Subject: Dresden Nuclear Power Station Units 2 and 3
Quad Cities Nuclear Power Station Units 1 and 2
Request for EXIGENT LICENSE AMENDMENT,
to Facility Operating Licenses DPR-19, DPR-25, DPR-29, and DPR-30
NRC Docket Nos. 50-237/249 and 50-254/265

DESCRIPTION AND SAFETY ANALYSIS OF THE PROPOSED CHANGES

BACKFILL MODIFICATION DRESDEN/QUAD CITIES

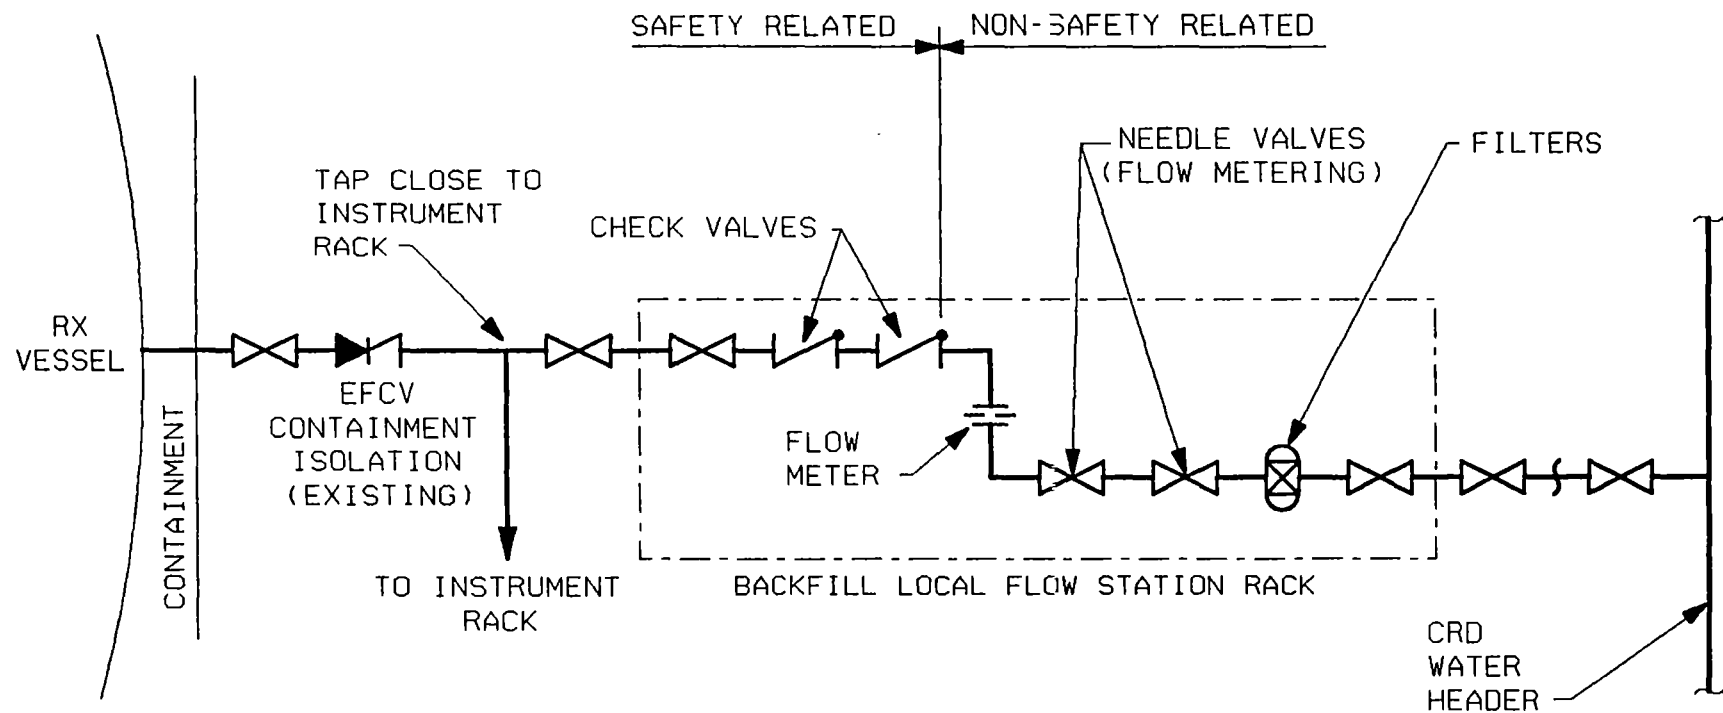
Implementation of the modification creates the potential for pressurizing one of the RVLIS reference legs to CRD drive water header pressure in the event of a root valve closure with the backfill subsystem in operation (see attached drawing). The condition could activate RPV low level safety features as well as RPV high pressure safety features depending on which valve is closed.

The new backfill subsystem utilizes water from the CRD drivewater header. This water supply flows to each of 2 instrument racks, 2201(2)-5 and 2201(2)-6 at Quad Cities and 2202(3)-5 and 2202(3)-6 at Dresden. Near these racks is a new panel with 2 flow stations and a water filter which acts as a pressure snubber. Each flow station consists of: needle valves for system startup and shutdown; metering valves for flow regulation; local flow indicators for setting flow rates through the backfill line for each reference leg; multiple check valves for SR-to-NSR and/or system separation; instrument taps for testing components; a vent connection for purging air from the lines; and isolation valves to isolate components for maintenance. A detailed drawing of the preliminary design is attached.

The speculated consequences of the inadvertent closing of each reference leg root valve without first isolating the backfill subsystem are estimated below.

Condensate Pot [Quad Cities 1(2)-0263-12A Dresden 2(3)-0263-12A]

- * All reactor vessel relief valves open immediately due to high indicated pressure (greater than 1135 psig)
- * High Pressure reactor SCRAM

- * Isolation Condenser initiation due to high pressure [Dresden]
- * Low water level reactor SCRAM
- * Low-low water level Group 1 isolation (MSIV's close)
- * HPCI starts and injects on the (false) low-low water level
- * RCIC starts and injects on (false) low-low water level [Quad Cities]
- * Low pressure ECCS systems start on low pressure permissive signal or after 8.5 minutes, whichever occurs first
- * Some false low water level indications in the Control Room, but most are unaffected

Condensate Pot [Quad Cities 1(2)-0263-12B Dresden 2(3)-0263-12B]

- * Same as 1(2)-0263-12A [Quad Cities] or 2(3)-0263-12A [Dresden], except that reactor vessel relief valves will not open immediately on high pressure but may open after 8.5 minutes to perform the function of ADS

The primary concern is a mismanipulation of the valves while the unit is at power. This scenario is unlikely because these valves are located at the penetration where there are no normally operated valves. To further minimize the possibility of a valve error, the valves will be locked in the open position with a lock, the keys for which are administratively controlled. In addition, labels that clearly identify the valves will be provided at the valve location indicating that operation of the valves will result in a plant transient and that they are not to be operated without permission of shift supervision.

The failure of the CRD piping integrity could result in challenges to the RPV instrumentation due to reference leg leakage. The isolation action of the two (2) backfill instrument line check valves mitigates this condition. The check valves allow flow to the vessel instrumentation reference leg piping and prevent flow out of the reference leg piping.
